City of Brisbane

Planning Commission Agenda Report

SUBJECT: **3000-3500 Marina Boulevard; Design Permit DP-1-21;** SP-CRO Sierra Point Commercial District; Design Permit revision to modify the north and south elevations of Buildings 1 and 2 and the west and east elevations of Building 3 of the three-building biotech campus previously approved under DP-1-18; David Diamond, applicant; Bp3 Sf5 3000 3500 Marina LLC, owner.

GENESIS MARINA
OVERVIEW OF DESIGN EVOLUTION

Side Elevations of Building Frame Extensions

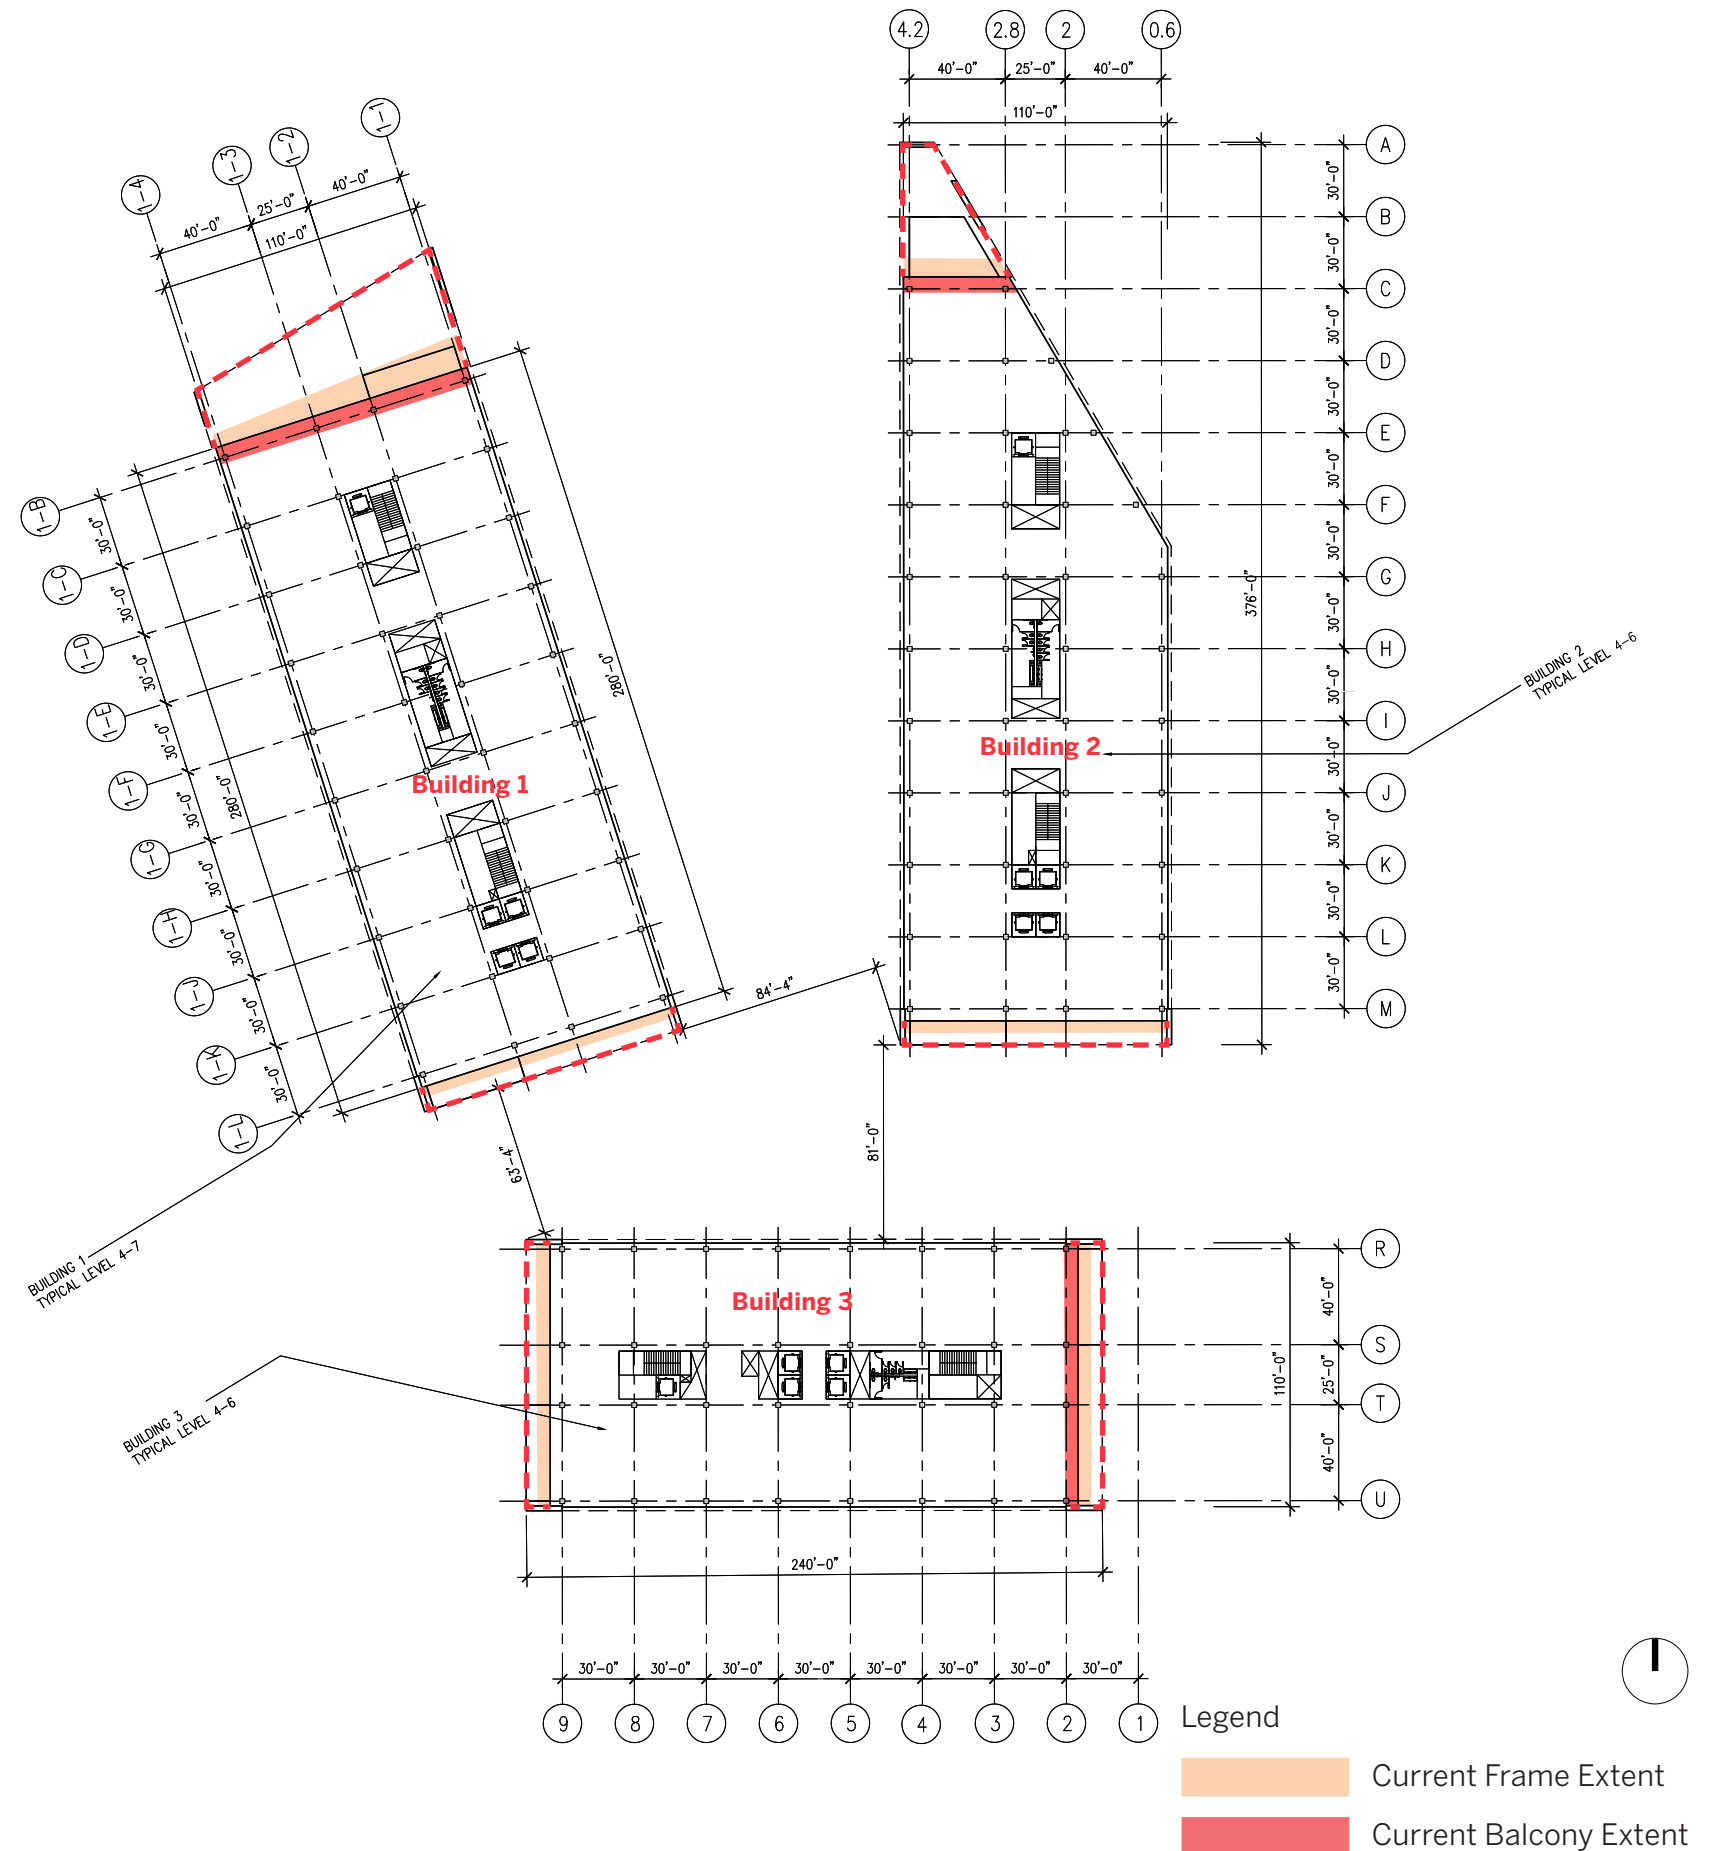
DESIGN CHANGES, INITIAL SUBMITTAL TO PRESENT

- North frame overhanging roof projection reduced to a dimension varying 5' to 10'
- South frame overhanging roof projection reduced to a dimension of 5'
- North end partial-width projecting balconies at L4 & L6 replaced with full-width inset and covered balconies at L3 & L6
- South end partial-width projecting balconies at L4 & L6 removed

- North frame overhanging roof projection reduced to a dimension of 15'
- South frame overhanging roof projection reduced to a dimension of 5'
- North end partial-width projecting balconies at L3, L4 & L6 replaced with full-width inset and covered balconies at L3 & L6
- South end partial-width projecting balconies at L4 & L6 removed

- East and West frame overhanging roof projections reduced to a dimension of 5'
- East end partial-width projecting balconies at L4 & L6 replaced with full-width inset and covered balcony at L7
- West end partial-width projecting balconies at L4 & L6 removed

- Exterior fly-by panels revised from open area/partial-width perforated metal screen panels which were eliminated and replaced with full-width sawtooth curtain wall panels with fritted glass

PROPOSED EXTERIOR ENLARGED ELEVATION & PLAN

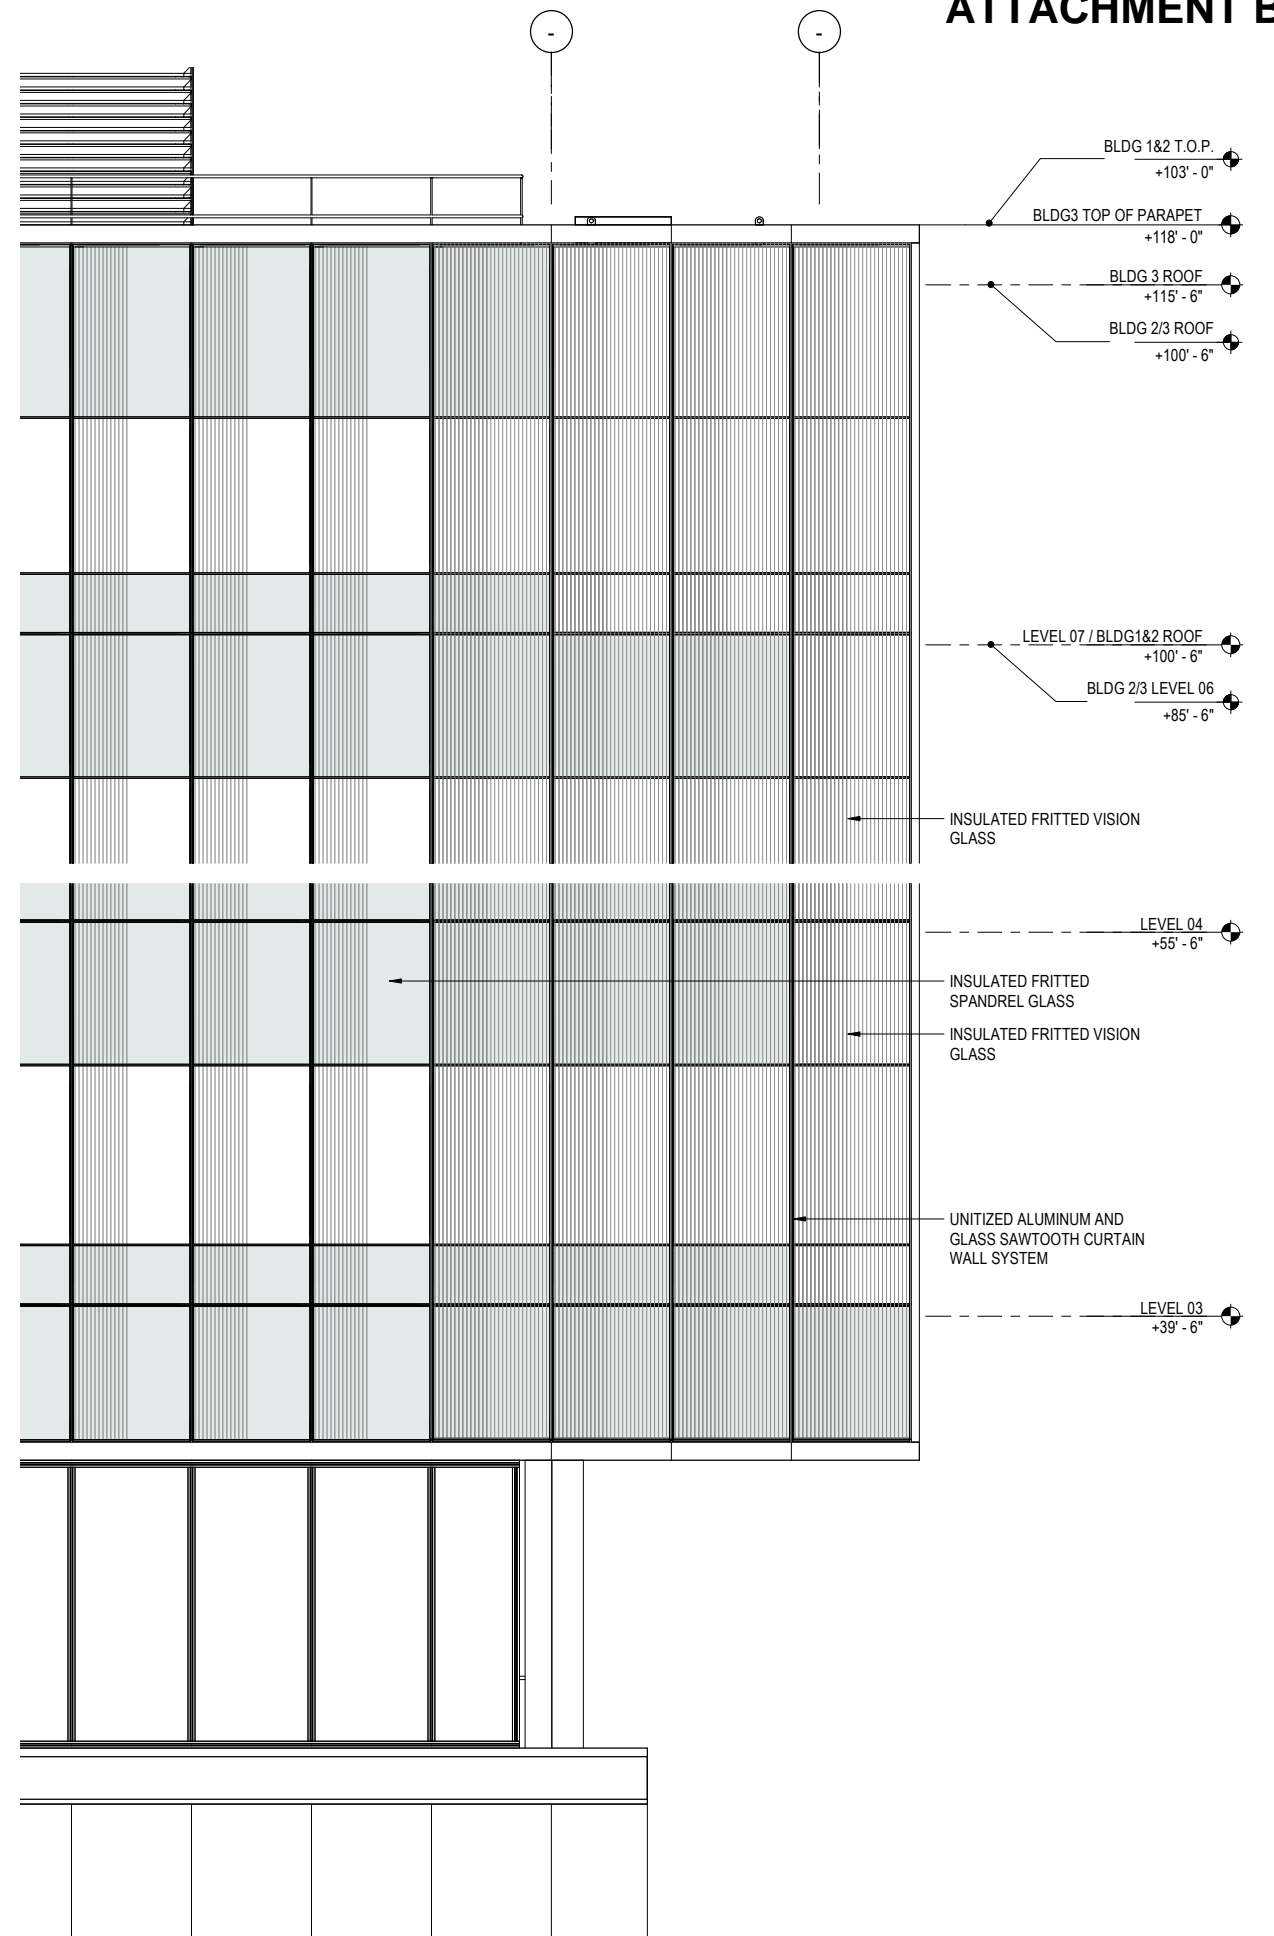
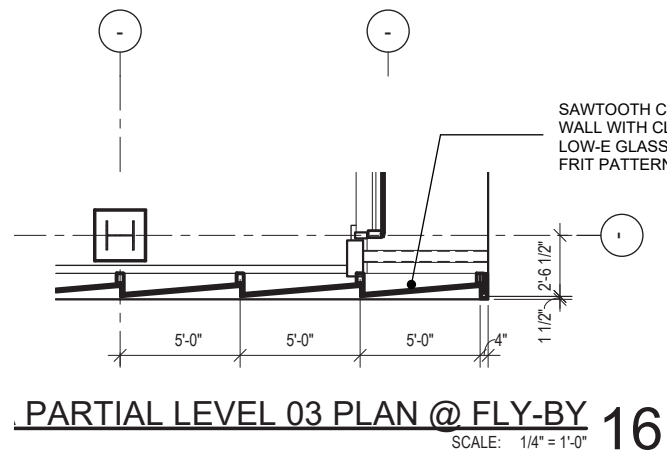
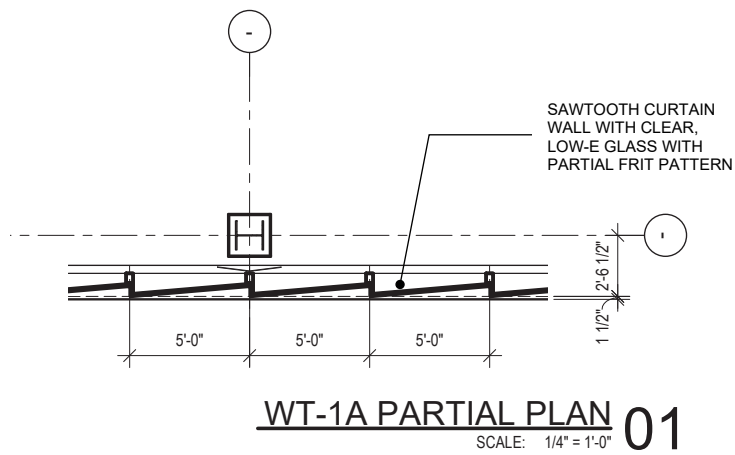
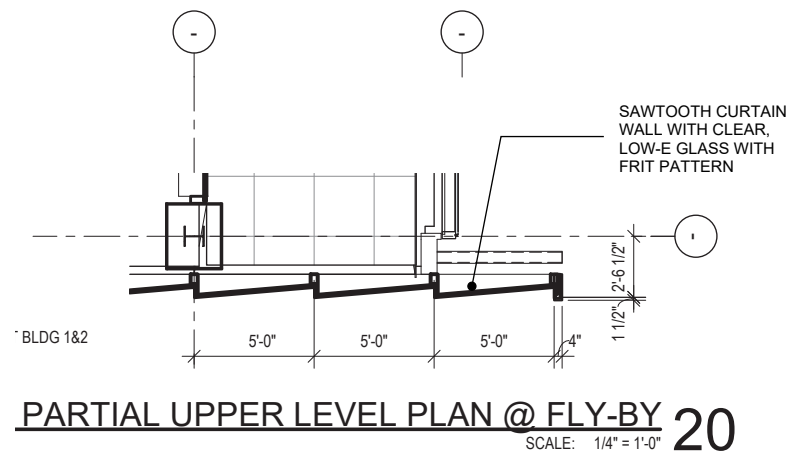
At all building end elevations, the applicant proposes modifying the materials of the decorative overhangs from perforated corrugated metal panels (approved in DP-1-18) to insulated fritted glass with aluminum framing within a sawtooth curtain wall. As described by the applicant, fritted glass is achieved by fusing opaque ceramic paint to the back side of the glass in a vertical line pattern. The frit improves the energy performance of the glass by providing some shading and reducing the solar heat gain in the interior of the building, and reduces glare on the exterior. The sawtooth curtain wall refers to the offset placement of the glass panes in a staggered fashion. Refer to Attachment B for the applicant's elevations with details showing the configuration of the sawtooth curtain wall.

The materials on the side elevations at the projecting ends of Buildings 1, 2 and 3 were revised to a semi-transparent fritted glass sawtooth curtain wall panel system (from the originally-presented perforated metal panels).
